Transnuclear Handouts – Part 3 of 6 - 10/07/09 Public Meeting
(Draft RAI Responses – non-proprietary)

RAIs and Responses

Enclosure 2 to E-xxxxx

Figure 2-8.1 – TN 40 Shell Flange, Nodal Stress Intensity Distribution for A12 (Cold)

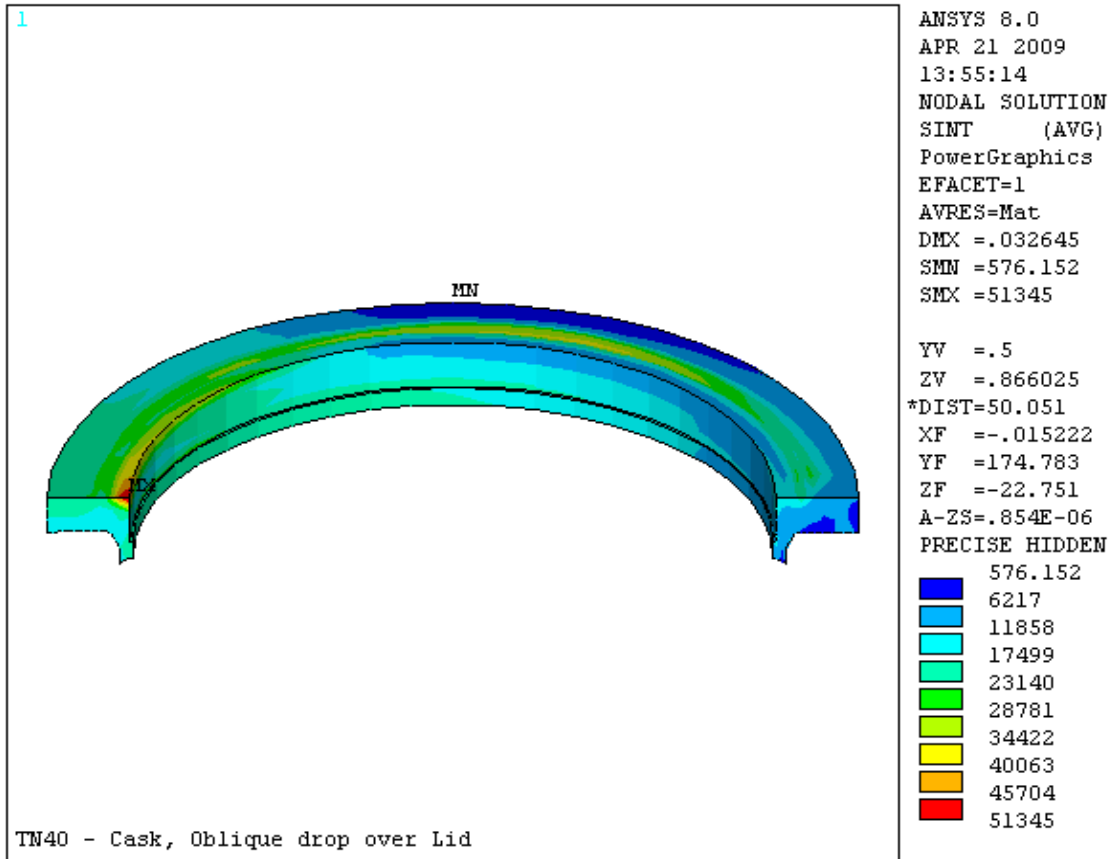
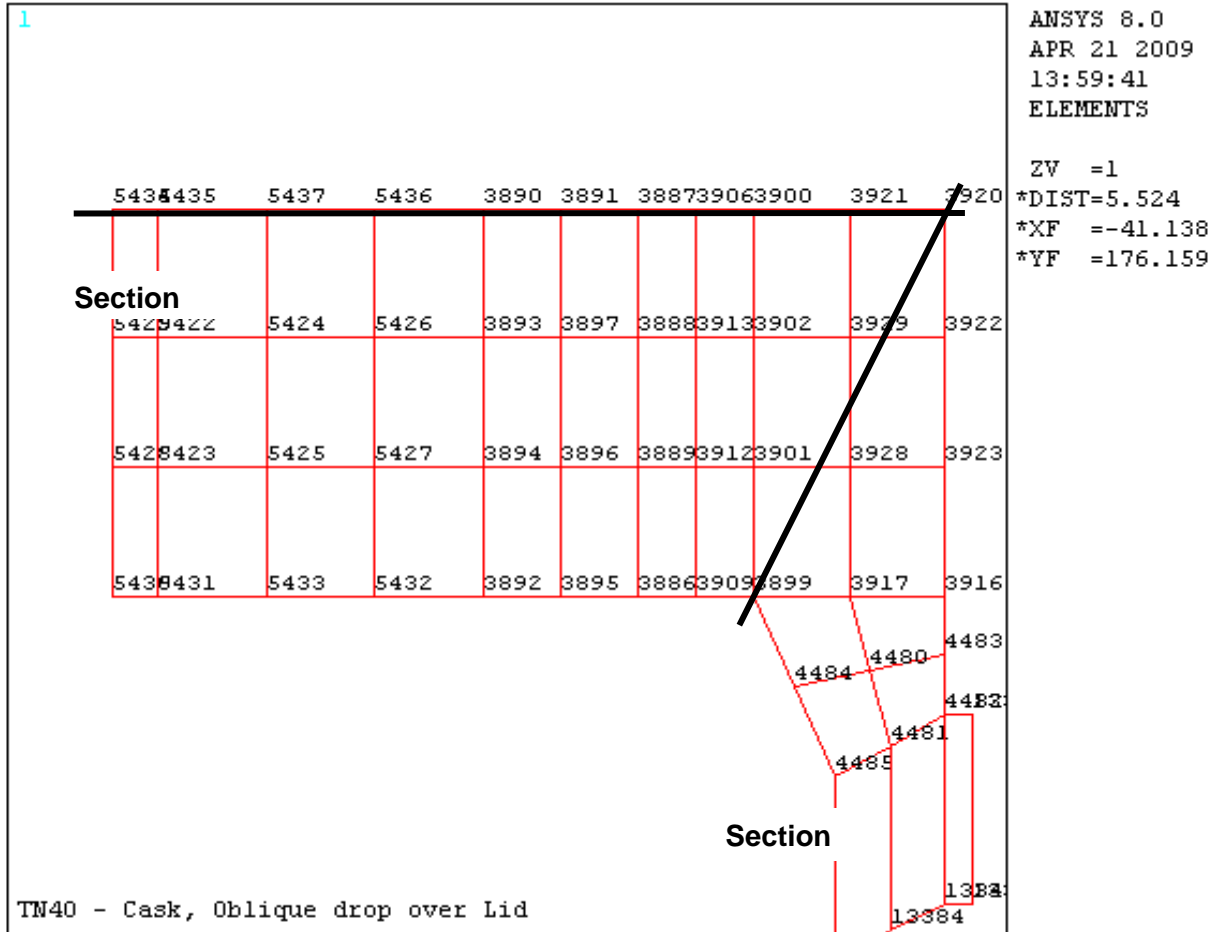
2-8 Verify that the cross section is appropriately selected for evaluating the maximum stress intensity for the containment boundary shell flange for the load combination Case A12, which includes the cold, 30-ft slapdown drop event.

The nodal stress intensity distribution in the shell flange for load combination Case A12 is shown in Figure 2-8.1. This load combination includes the cold, 30-ft slapdown drop on lid event. It is seen that the maximum nodal stress intensity of 51.35 ksi occurs at node number 3920 located at flange inner diameter corner. Flange node numbers at a section through 3920 are shown in Figure 2-8.2. The two cross sections from the highest stress intensity node 3920 shown in Figure 2-8.2 are considered bounding. One cross section is defined by nodes No. 3920 and No. 5434 and other cross section is defined by nodes No. 3920 and No. 3899. Stresses are linearized at both the cross sections. The stress linearizing details at these two cross sections is given in Tables 2-8.1 and 2-8.2. A summary of stress intensities is given below:

It is seen from above that cross section 1, defined by nodes No. 3920 and No. 5434, has the higher stresses and was therefore appropriately selected for reporting shell flange stresses in SAR.

Figure 2-9.1

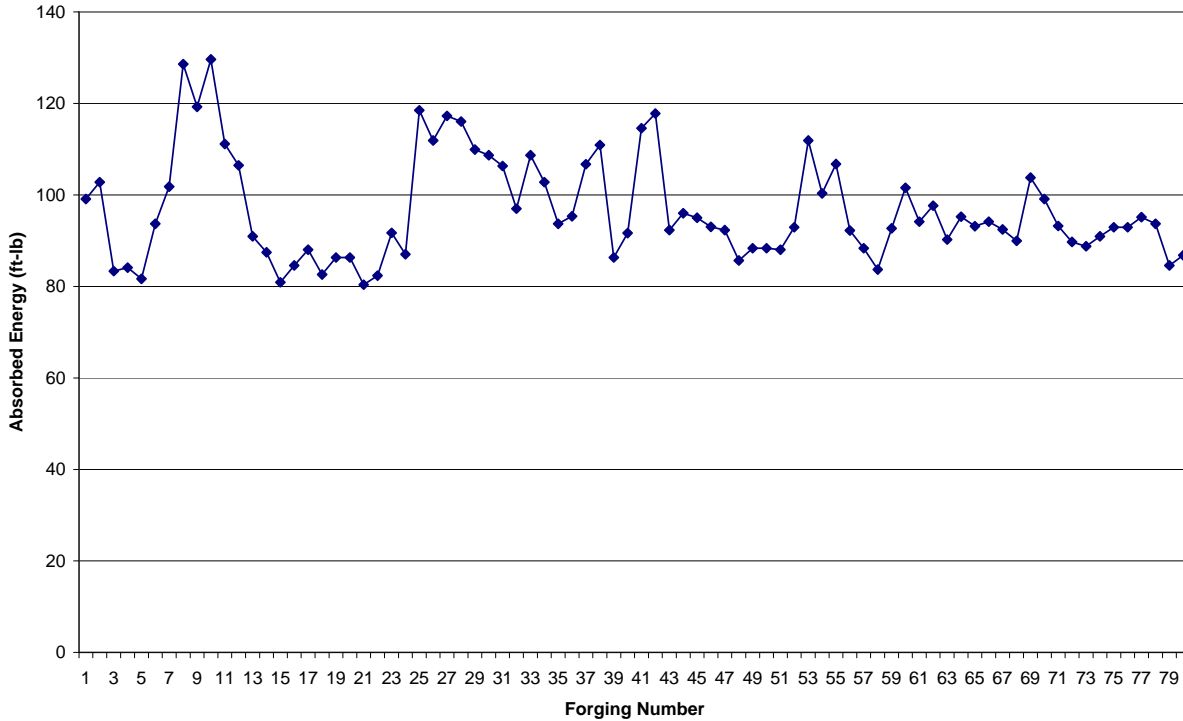
- 2-9 Provide justification that the testing, using a limited combination of potential base metals, filler materials, and weld techniques (2 tests), bounds the worst case fracture toughness expected from all potential combinations of these three parameters. Explain why TN fabricators chose the combination of weld processes, electrodes, and base material presented in the table to demonstrate the toughness of the weld and heat affected zone (HAZ). Defend why the table data are representative of all other possible combinations which can be used, or are these data the best case scenario?

For current procurement, each TN-68 Shield Shell is fabricated from two forgings. Fracture toughness test results (-20F Charpy V-notch testing) for forty forgings is available and shown in Figure 2-9.1.

The average test result for the forty TN-68 Shield Shells at -20°F was 96.6 ft-lb with a standard deviation of 11.3 ft-lb. The TN-68 results are both much higher (over five times) than the TN-40 requirement of 18 ft-lb and very consistent. 18 ft-lb equals the average TN-68 result minus nearly seven standard deviations. These results strongly support the conclusion that the fracture toughness properties of the TN-40 Shield Shells exceed the minimum required by a margin which can safely accommodate any realistic variations in chemical composition and physical processing as well as the effects of welding.

Heat-to-heat variation in stress-strain diagram for 304 stainless steel tested at (a) 24°C, (b) 93°C, (c) 204°C, and (d) 316°C.

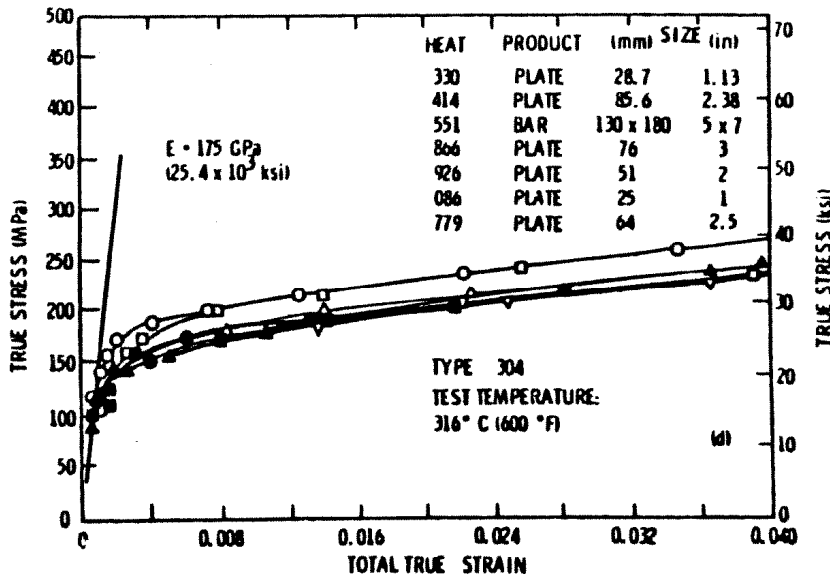
2-12 On page 2.10.5-4, provide data or reference to show that a 5% strain-hardening rate ($E_p/E = 0.05$) is conservative for the bilinear stress-strain curve implemented for both the SA-240 Type 304 SS steel and SB-209 Type 6061-T651 aluminum alloy plates in the basket non-linear finite element structural analysis.

A figure with representative stress-strain curves for SA-240 Type 304 is shown below. The figure is taken from NUREG/CR 0481 [1]. This figure is used as a basis for the 5% strain-hardening rate shown in the bilinear stress-strain curve.

Using a 5% strain-hardening rate, which is greater than those shown in the figure above, is conservative because it will yield higher stresses. The maximum stress in the SS Boxes is less than 30 ksi (~201 MPa); thus the material remains in the low plastic strain region where the effect of the strain-hardening rate is minimal.
